Subject: Inservice Testing Program Relief Request RP-06, Revision 1
Cooper Nuclear Station, NRC Docket 50-298, DPR-46

**Responses to NRC Request for Additional Information
Relief Request RP-06**

Relief Request RP-06 (Revision 1)

Figure 1 - CS-P-B Vibration Monitoring Points

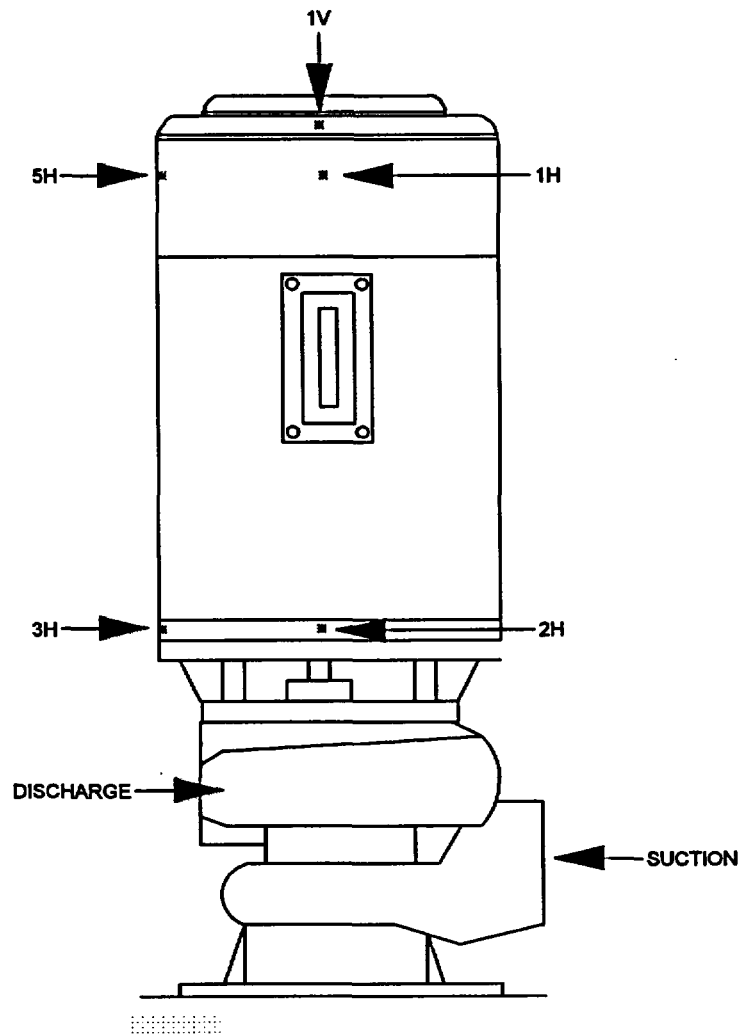
The Inservice Testing (IST) Program has consistently required that CS-P-B be tested on an increased frequency due to vibrational values at points 1H and 5H, as shown in Figure 1 of Attachment 3, periodically being in the alert range. Relief is requested to exclude from consideration the vibration in the frequency range from one-third pump rotational speed up to one-half pump rotational speed for points 1H and 5H. Excluding this low frequency vibration band will filter out piping-

ALTERNATE TEST The vibration at points 1H and 5H on CS-P-B will be monitored over the range of frequencies from one-third pump rotational speed to 1000 Hertz required by ASME Code OMa-1988, Part 6, Paragraphs 4.6.1.6, 4.6.4, and 5.2(d). The vibration occurring at frequencies between one-third and one-half pump speed at points 1H and 5H will be administratively monitored and any anomaly or trend of high vibration or degraded pump performance will be addressed. However, this vibration will not be included in the IST overall vibration averages for points 1H and 5H. Only the vibration occurring at frequencies from one-half pump

Figure 2a

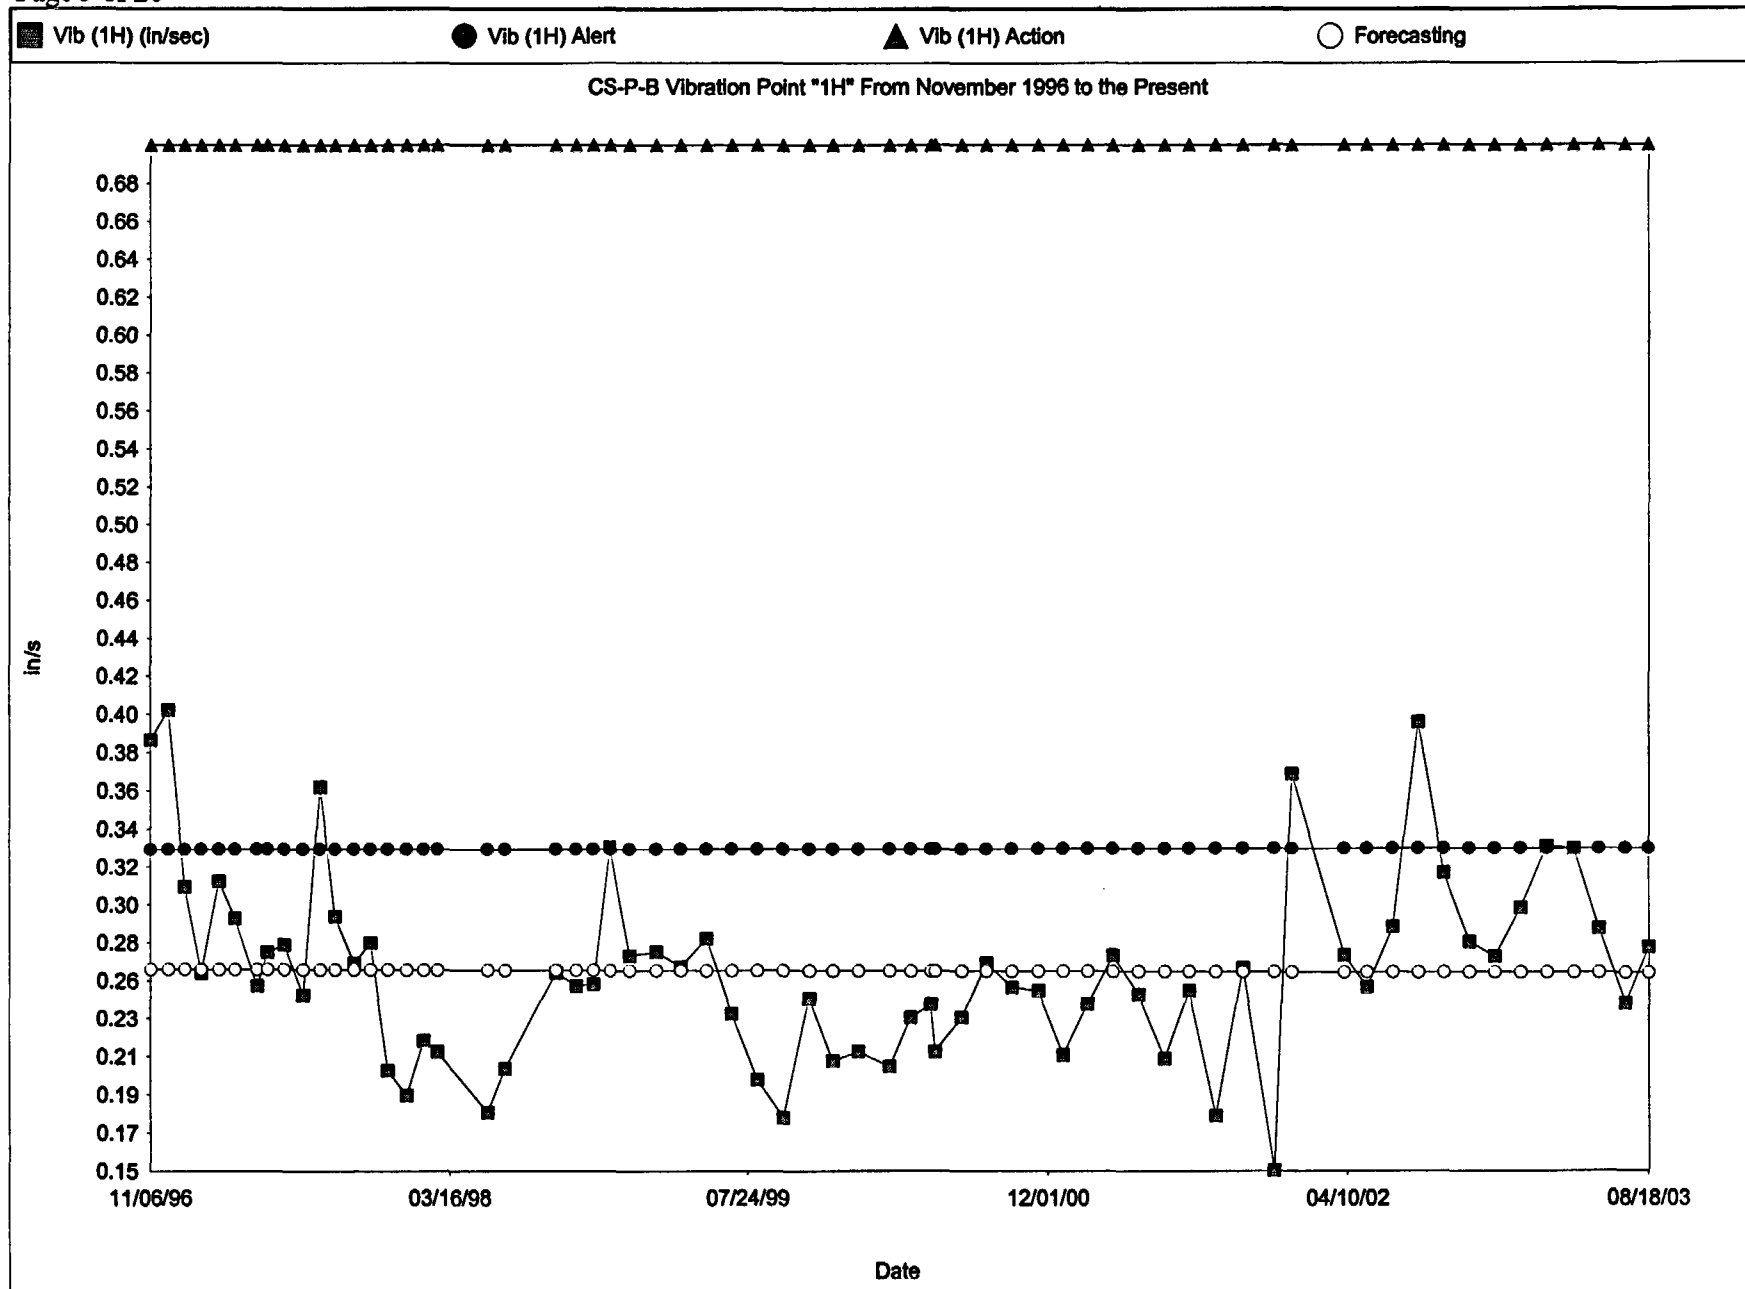
In reviewing the trend data for vibration points 1H (Figures 2a, 2b) and 5H (Figures 3a, 3b), which includes the Code required frequency ranges (one-third pump running speed to 1000 Hz.), random spikes were observed throughout the data that resulted in values above the alert range. These spikes are best described in a 2001 report by Machinery Solutions, an industry expert on vibrations, as follows:

Figure 7

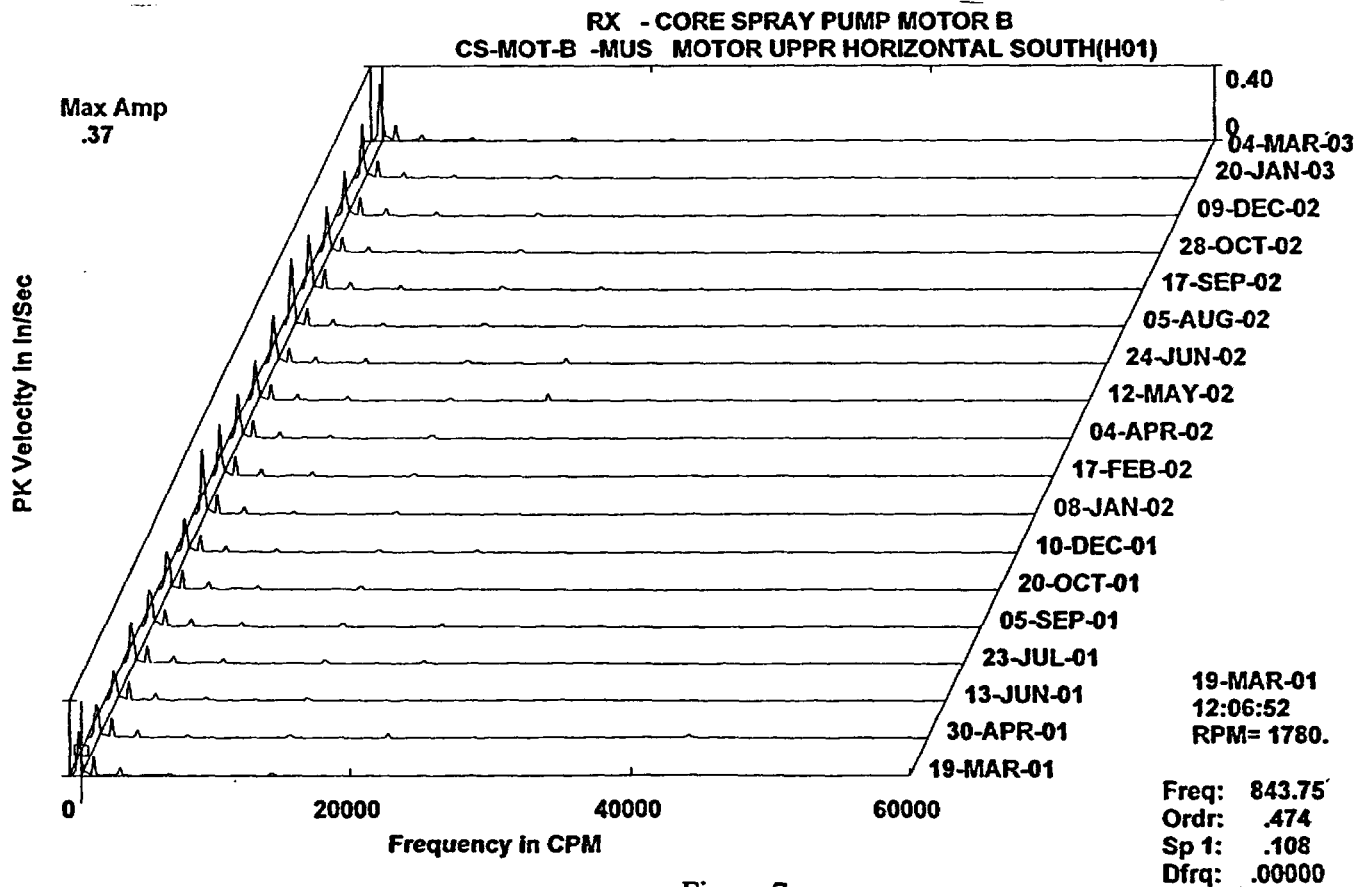
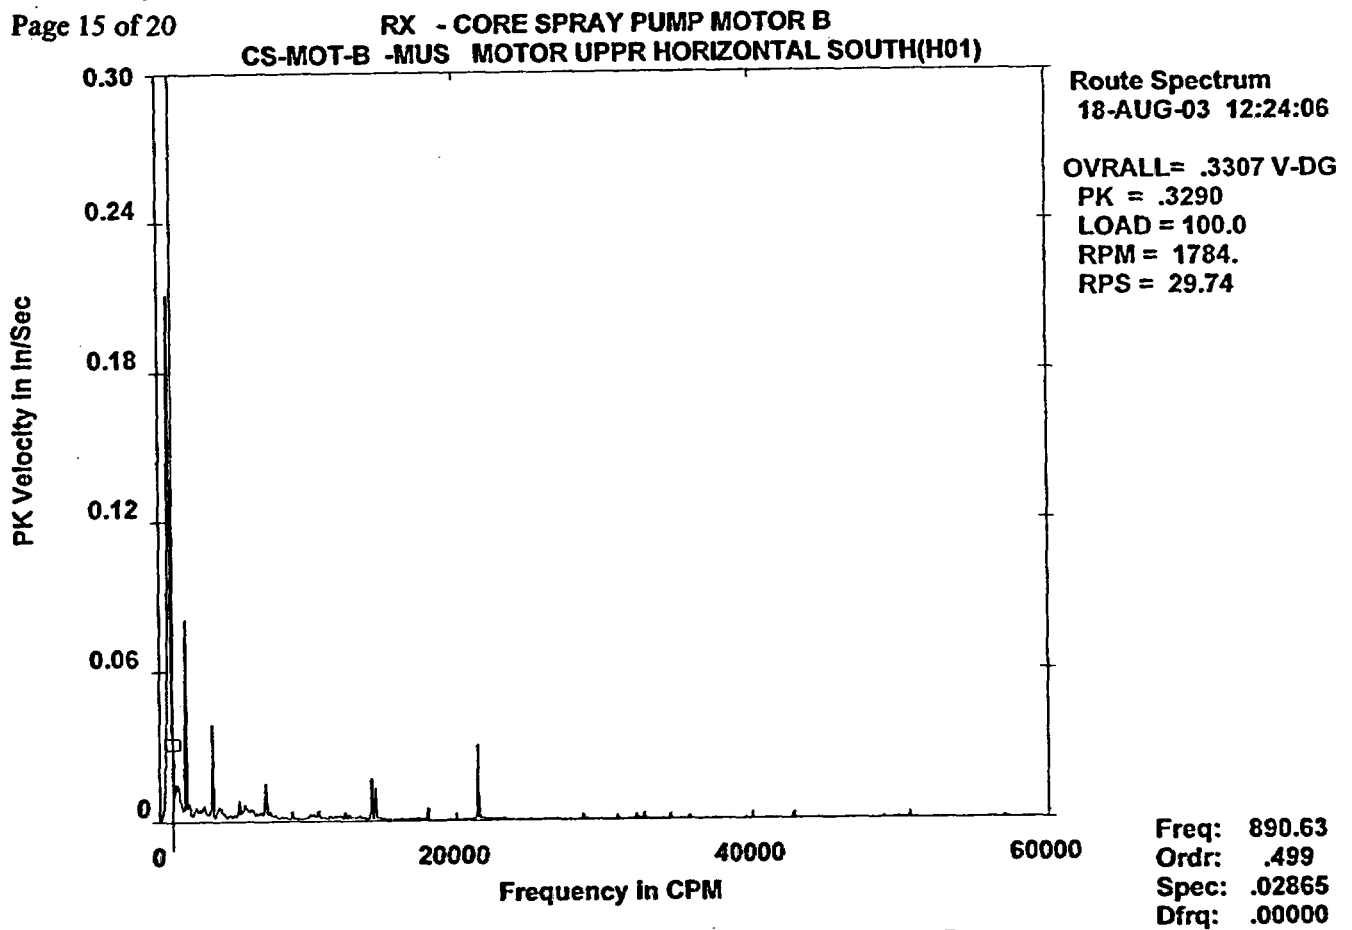
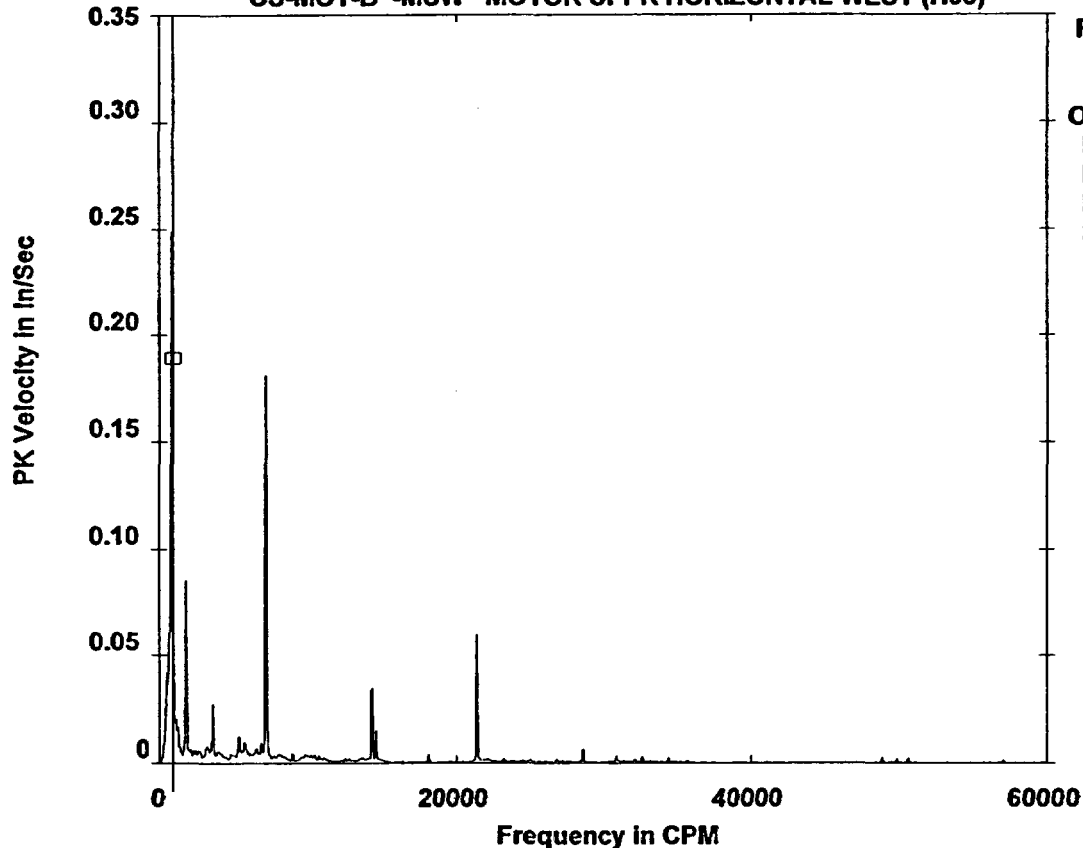
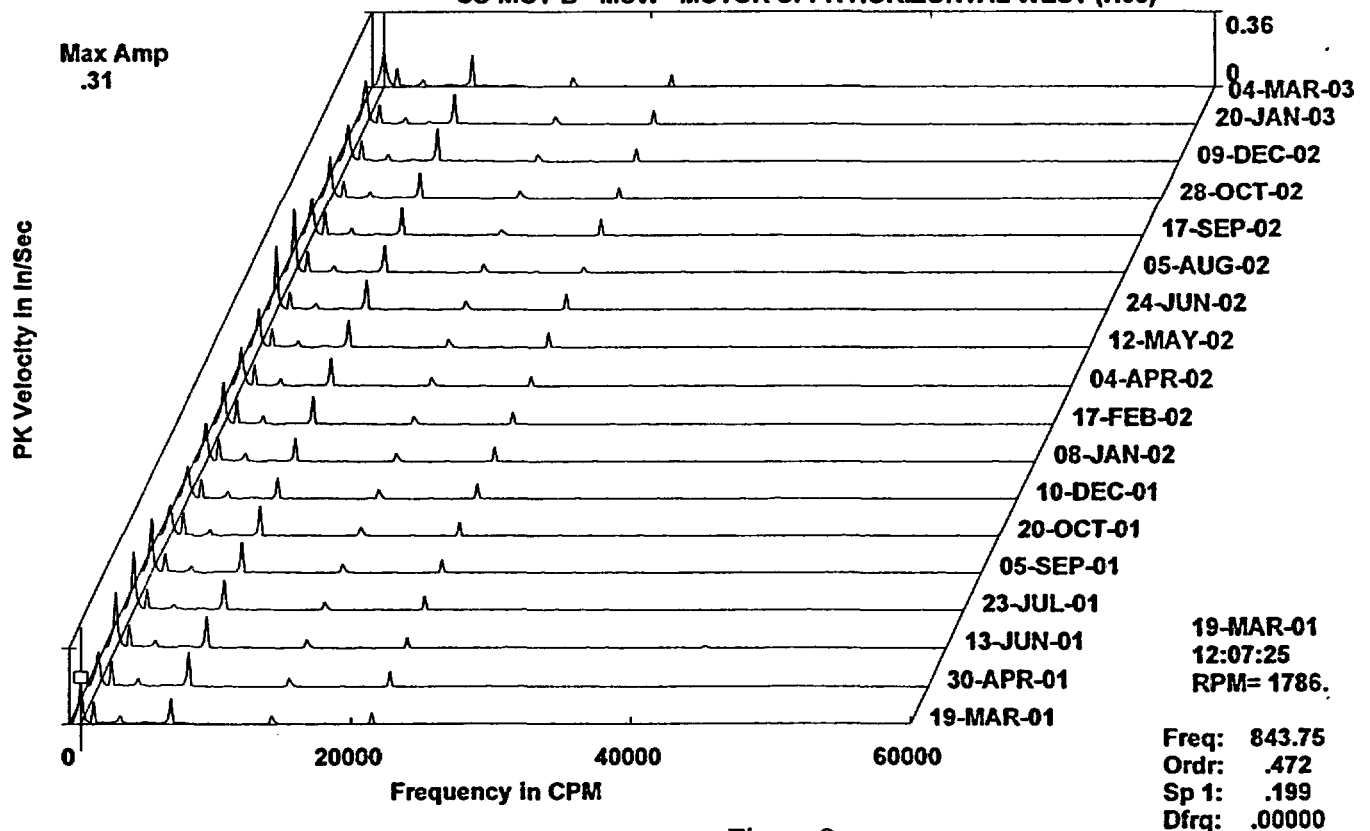
Figures 7 through 11 in Attachment 3 show spectrum plots for CS-P-B, as well as spectrum trends. Markers drawn on these plots show that the peak energy spikes for points 1H and 5H remain below one-half pump running speed and that the pump vibration signature remains fairly uniform. Figure 12 shows that pump differential pressure is consistently acceptable. This data validates the analysis performed by Machinery Solutions, Inc., and the earlier conclusions that the elevated vibrations are piping-induced, and not indicative of degraded pump performance. No pump or motor faults and/or degradation are evident in the spectral analysis for this pump. This test data also shows that the vibrations experienced remain in the region of the CS-P-B pump-motor-piping system natural frequency, at less than half the pump's operating speed.

Figure 12

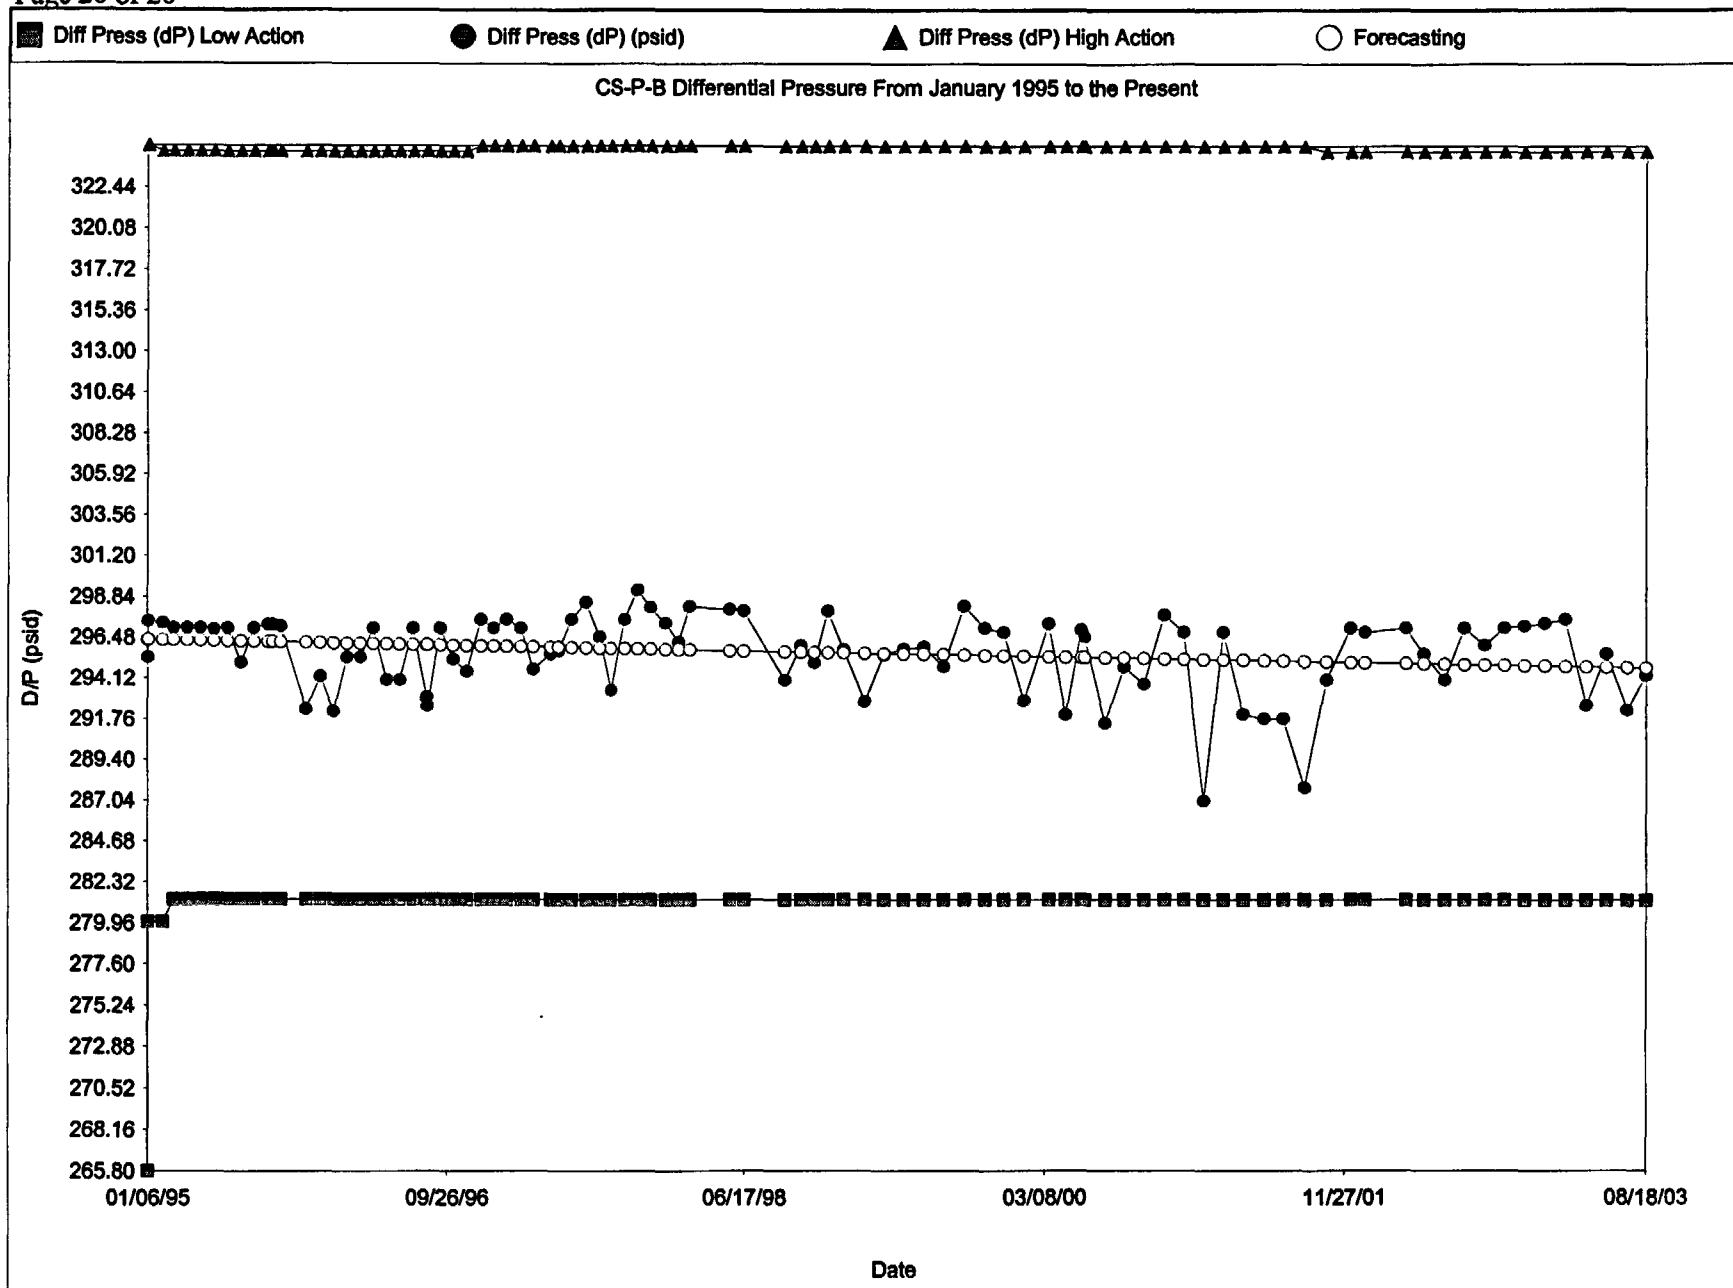
CS-P-B IST vibration trend graphs (Figures 2a, 3a, 4a, 5a, and 6a in Attachment 3), which include data from November 6, 1996 to the present, show essentially flat or slightly downward trends, indicating that CS-P-B vibrations are not increasing in magnitude. These trends also show that points 1H and 5H occasionally exceed the alert range criteria (Figures 2a and 3a). Figure 12 illustrates the trend for CS-P-B differential pressure (D/P) readings from January 1995 (re-baselined pump at 5000 gpm) to the present. This represents nearly nine years of data for pump differential pressure with the testing at 5000 gpm. As can be seen from Figure 12, essentially no degradation in pump D/P has occurred.
